**REVIEW OF THE DOE REPORT: "THE ORIGIN OF CALCITE-
SILICA DEPOSITS AT TRENCH 14 AND BUSTED BUTTE AND
METHODOLOGIES USED TO DETERMINE THEIR ORIGIN"**

**SPECIAL REPORT No.18
CONTRACT No. 94/96.0003**

**SPECIAL REPORT Submitted to the
Nuclear Waste Project Office
State of Nevada**

November, 1994

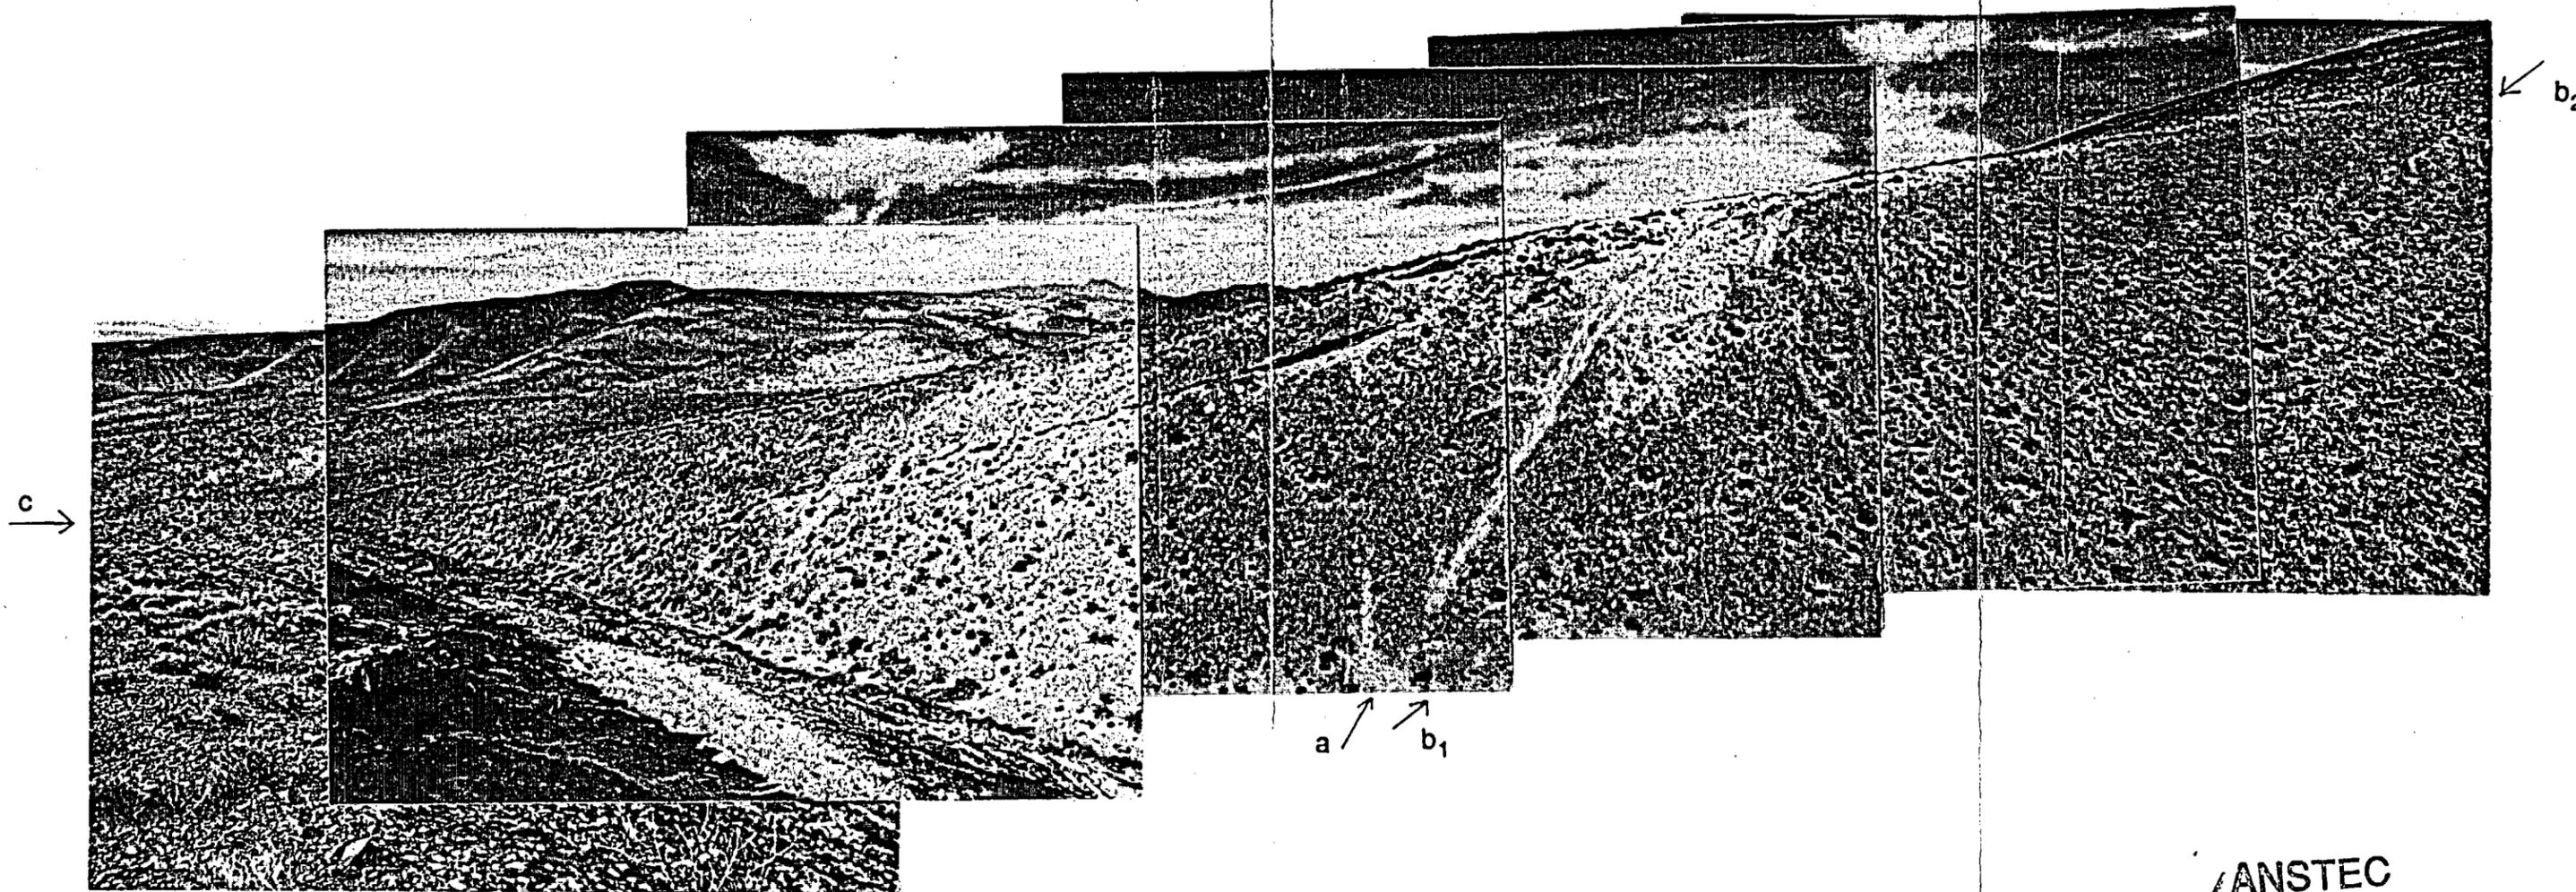
What is missing from this statement is that these slope-parallel deposits are developed mostly downslope of vertical calcite-silica veins, which in turn are developed along fault zones (see Fig. 16 on p.24 of the DOE Report), as should be expected for water

Figure 7 - The relationship between $\delta^{13}\text{O}$ and $\delta^{18}\text{O}$ for pedogenic carbonates and samples from the Trench 14 veins. From DOE, 1993.

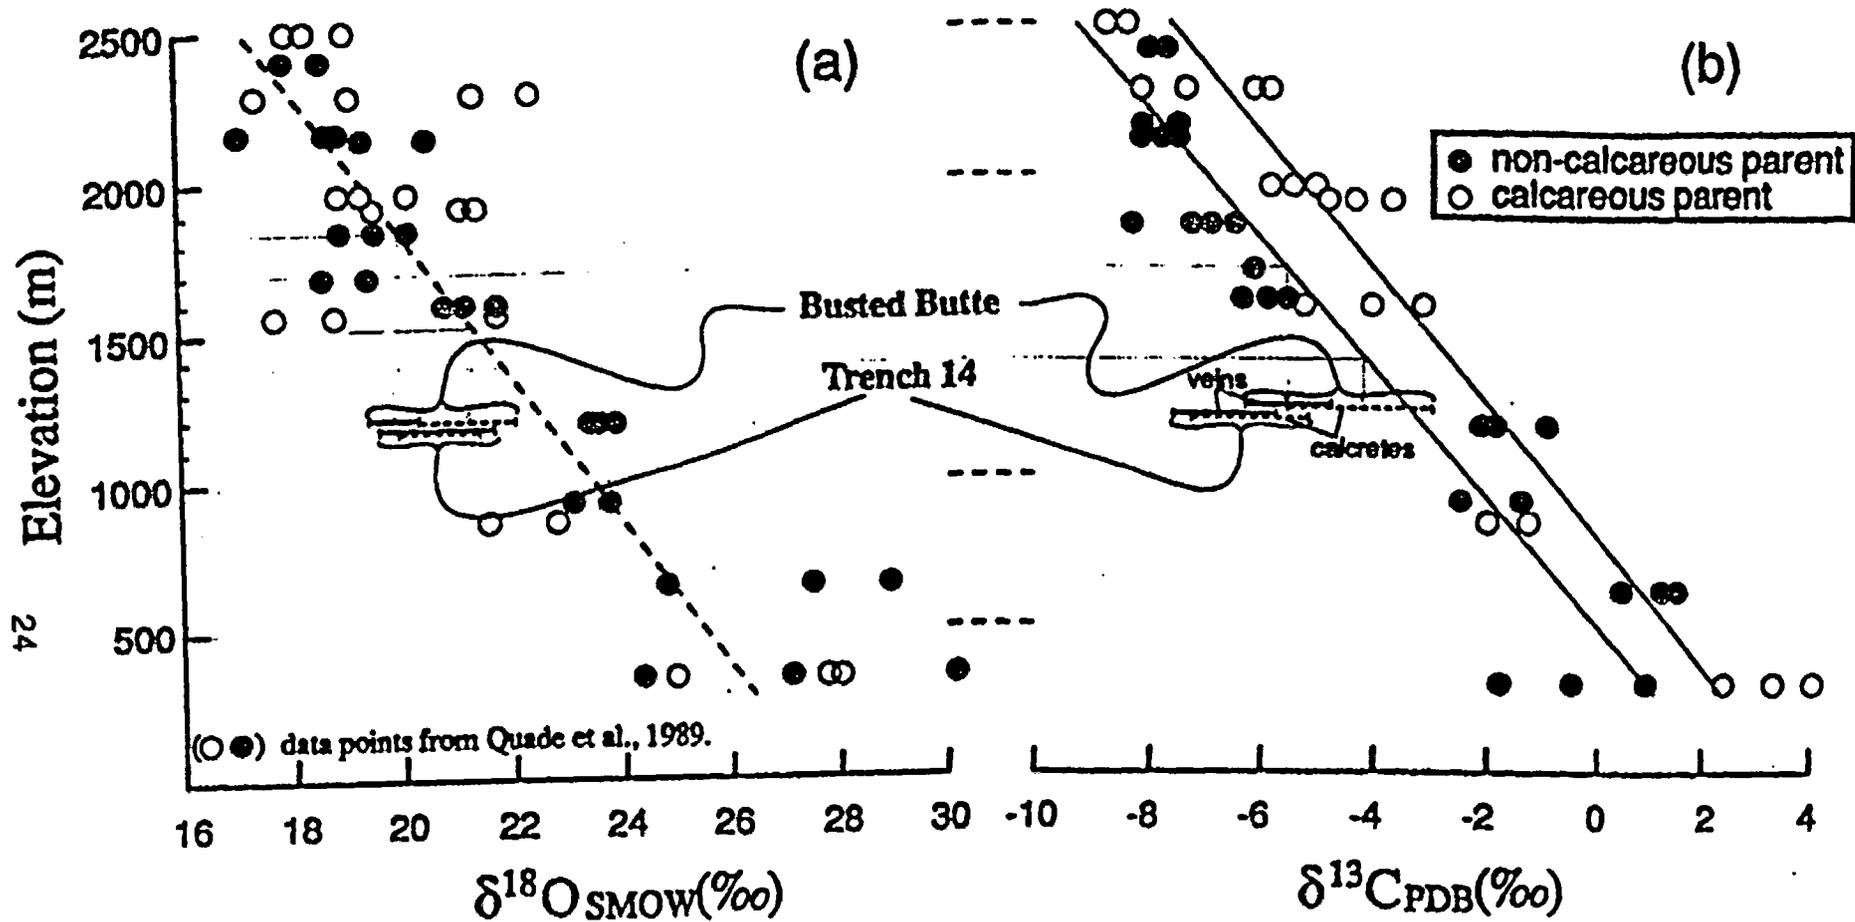
1. One may see from Fig. 10 of the DOE Report that calcretes from both Trench 14 and Busted Butte have $\delta^{18}\text{O}$ and $\delta^{13}\text{C}$ signatures of up to 4,5 permil lighter than pedogenic calcretes at the same altitude; so the statement that the samples are "virtually identical" is not true (Fig. 10 of the DOE Report is reproduced as Fig. 7).
2. It may also be observed, that there is a systematic shift for $\delta^{18}\text{O}$ and $\delta^{13}\text{C}$ in veins and slope calcretes at Busted Butte; both carbon and oxygen are lighter in veins and heavier in slope calcrete (Fig. 8; the data taken from Tables A-1 and A-2 of the DOE Report). Oxygen from Trench 14 displays the same behavior. Using the DOE's logic one must conclude that the veins at Busted Butte were formed at an altitude some 350m higher than the corresponding slope calcretes.

Figure 8 - Systematic change in ^{13}C and ^{18}O in veins and slope calcretes at Busted Butte.

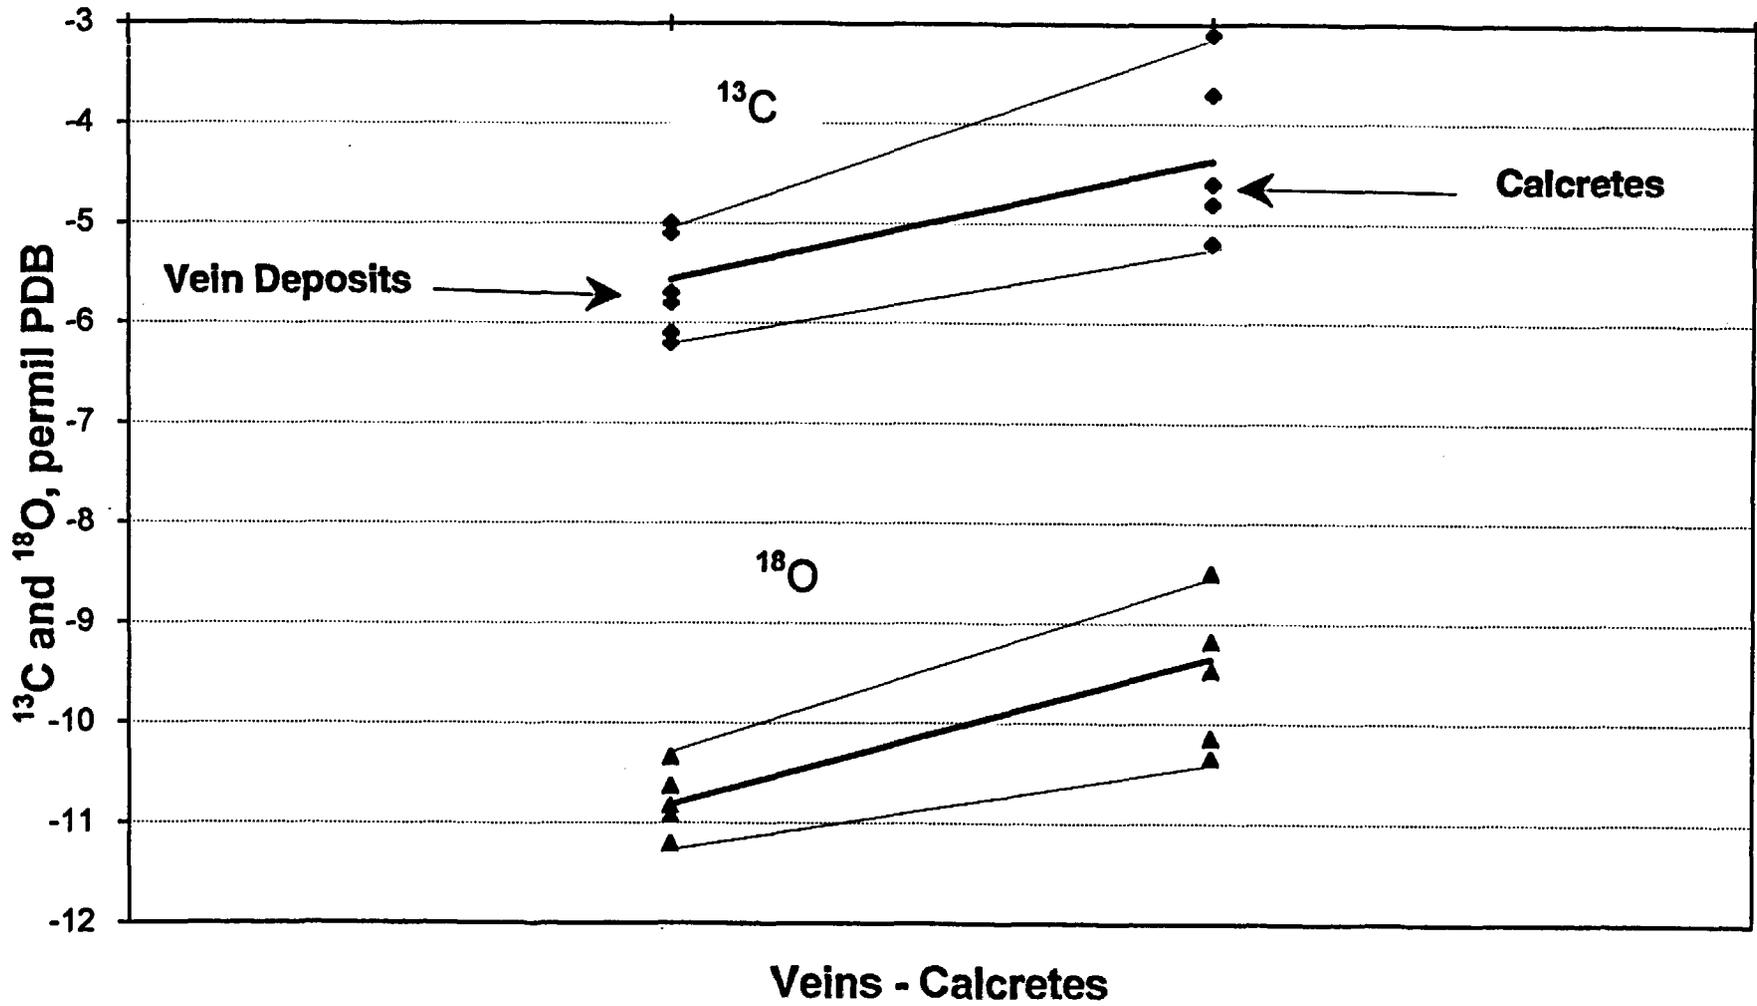
The systematic $\delta^{18}\text{O}$ and $\delta^{13}\text{C}$ shift is not discussed in the DOE Report. Such a behavior, however, may well be expected for *per ascensum* deposits. During deposition of such deposits upwelling fluids (along fault zones and discharging on the topographic surface) lose dissolved CO_2 and evaporate. During both CO_2 -degassing and evaporation the lighter isotopes ^{12}C and ^{16}O preferentially concentrate in the escaping gas phase and, thus, the carbonate-depositing fluids became progressively enriched in heavier isotopes (i.e., ^{13}C and ^{18}O). At Busted Butte, where sand ramps hosting the veins were truncated by erosion and the latter may be sampled to a significant depth from the topographic surface this trend is especially well pronounced. By contrast, in Trench 14 all the vein samples were taken at a depth of only 1-2 m below the topographic surface (see Plates 1-6 in Appendix D of the DOE Report), so the difference between these two types of calcite is less clear.

Figure 10 - ^{13}C in pedogenic carbonates (circles; by Quade et. al., 1988), spring deposits (squares; by Harmon, 1993, Hill and Schluter, 1994), Trench 14 and Busted Butte (triangles; by DOE, 1993). Thick solid line displays linear trend.

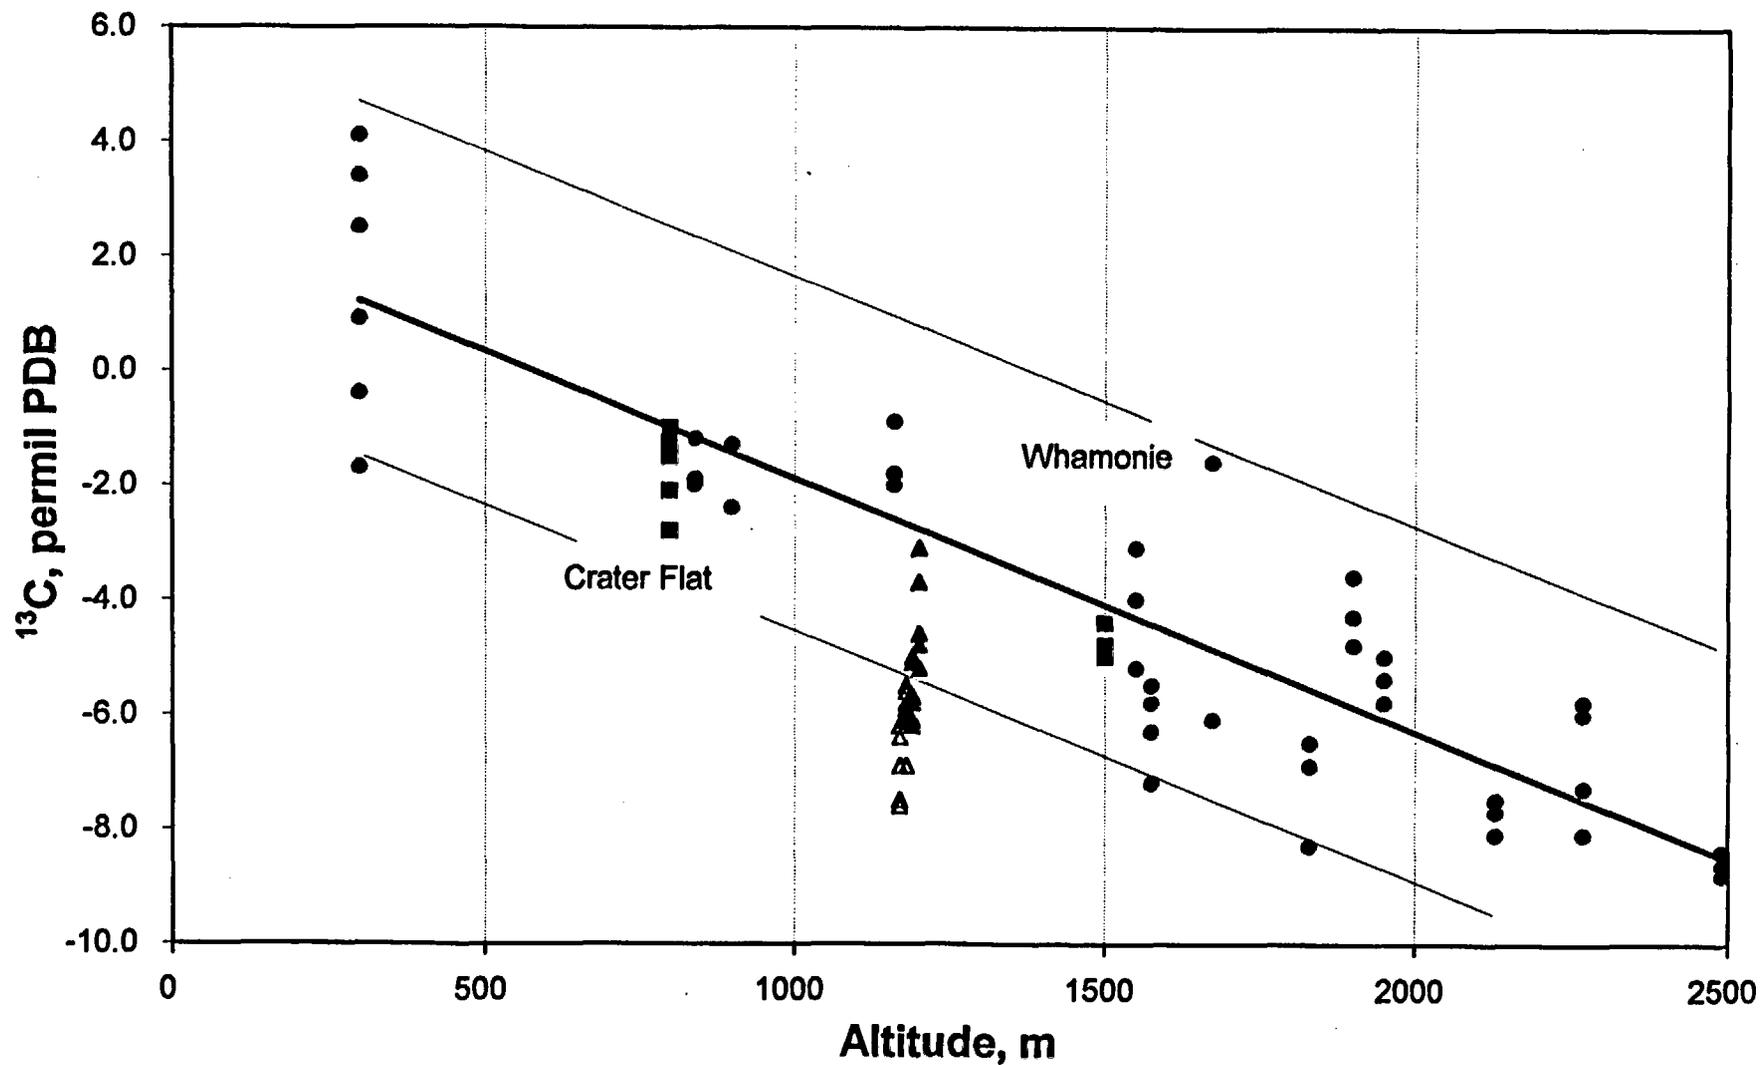
The results given in Figs. 9 and 10 clearly show that stable isotope signatures of calcite deposited from spring water match signatures obtained from "pedogenic" carbonates. As a matter of fact, the match of $\delta^{13}\text{C}$ from spring calcite is much better than that of carbon from calcite at Trench 14 and Busted Butte (Fig. 10). One obvious conclusion which can be drawn from these data is that, at Yucca Mountain, both

pedogenic process and ascending warm water would produce calcite with identical $\delta^{13}\text{C}$ and $\delta^{18}\text{O}$ signatures, and thus, these signatures can not be used to distinguish between the competing processes.

Figure 11 - Comparison of ^{13}C and ^{18}O signatures of vein and slope calcite from Trench 14 and Busted Butte (triangles) with those of calcite from spring deposits Whamonie mound and southern Crater Flat (squares) and "pedogenic" calcite (circles).

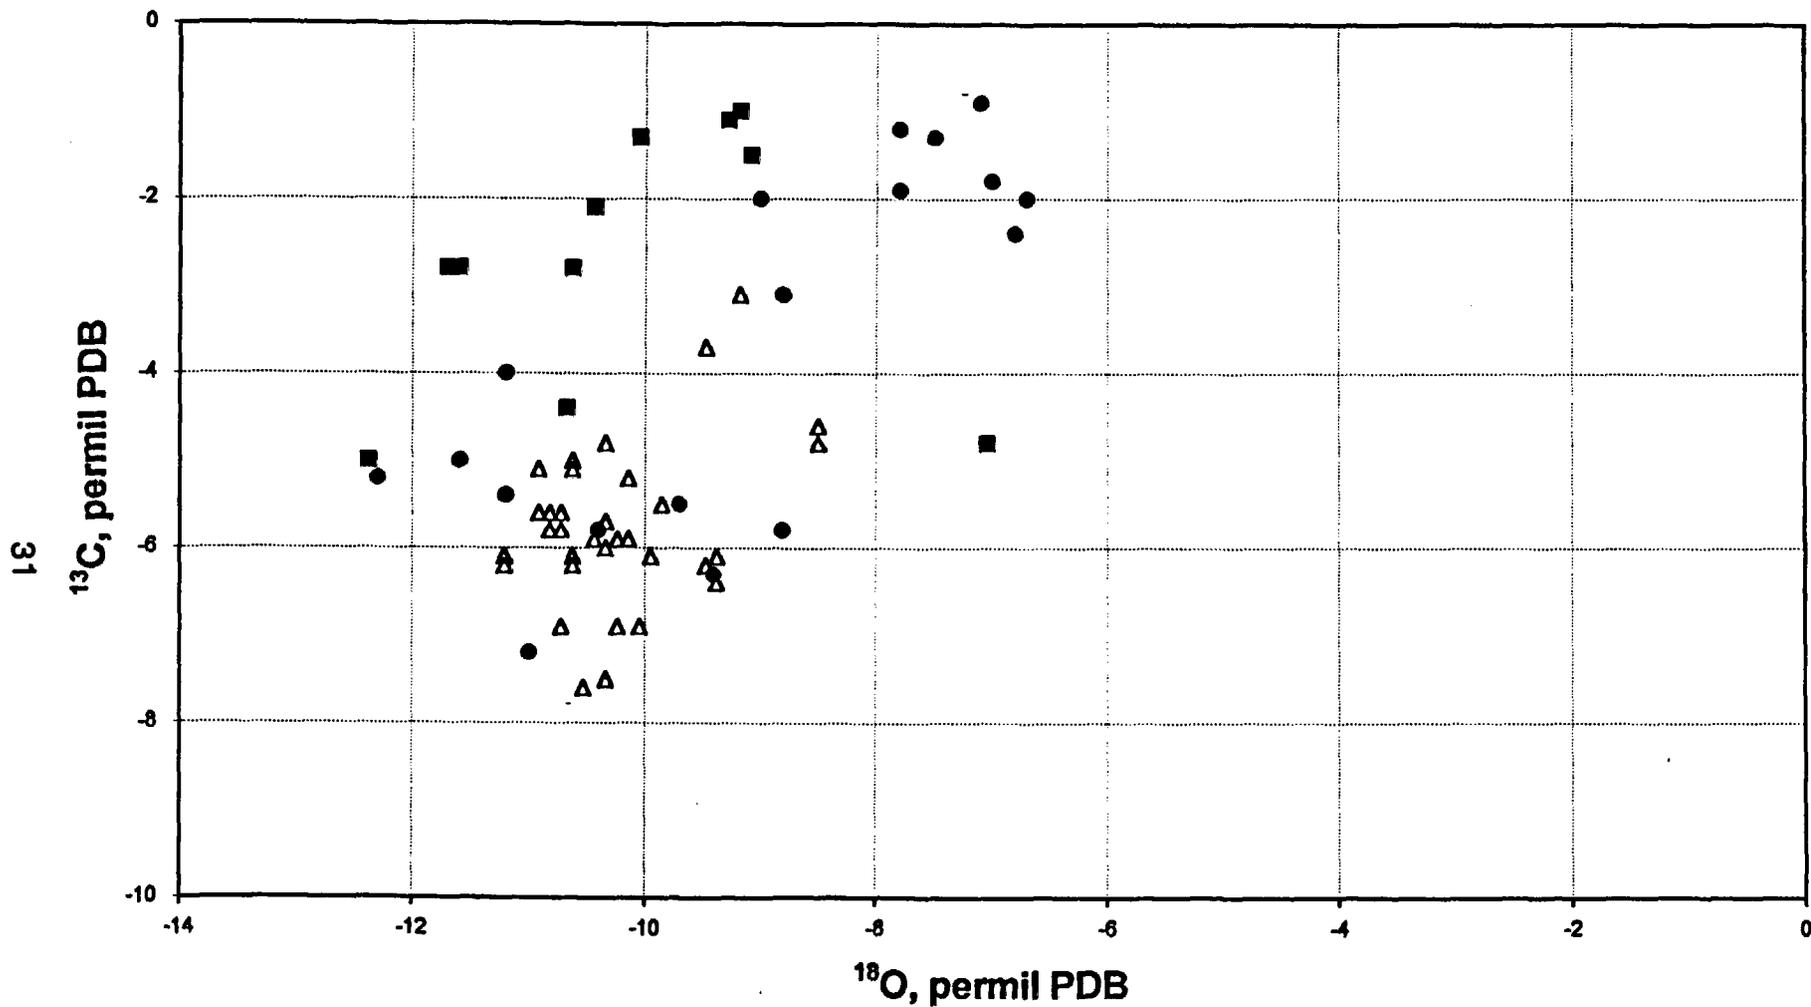
4. On the other hand, a simple and logical approach would be to compare the stable isotope signatures of calcite from Trench 14 and Busted Butte with those of calcite of known spring origin (Fig. 11). Two inferences can be drawn from the data shown in this figure. First, the $\delta^{13}\text{C}$ and $\delta^{18}\text{O}$ signatures of calcite from Busted Butte and Trench 14 overlap those of calcite from spring deposits. Second, in terms of carbon and oxygen isotopes these two types of calcite deposits are indistinguishable from "pedogenic" carbonates (the data for altitudes of 800 to 1700 m were taken from original Table by Quade et al.,1989). In light of these remarks, the approach employed by the DOE in performing analyses of stable isotope data must be regarded as scientifically invalid. Therefore, the conclusions resulting from these analyses are doubtful at best.
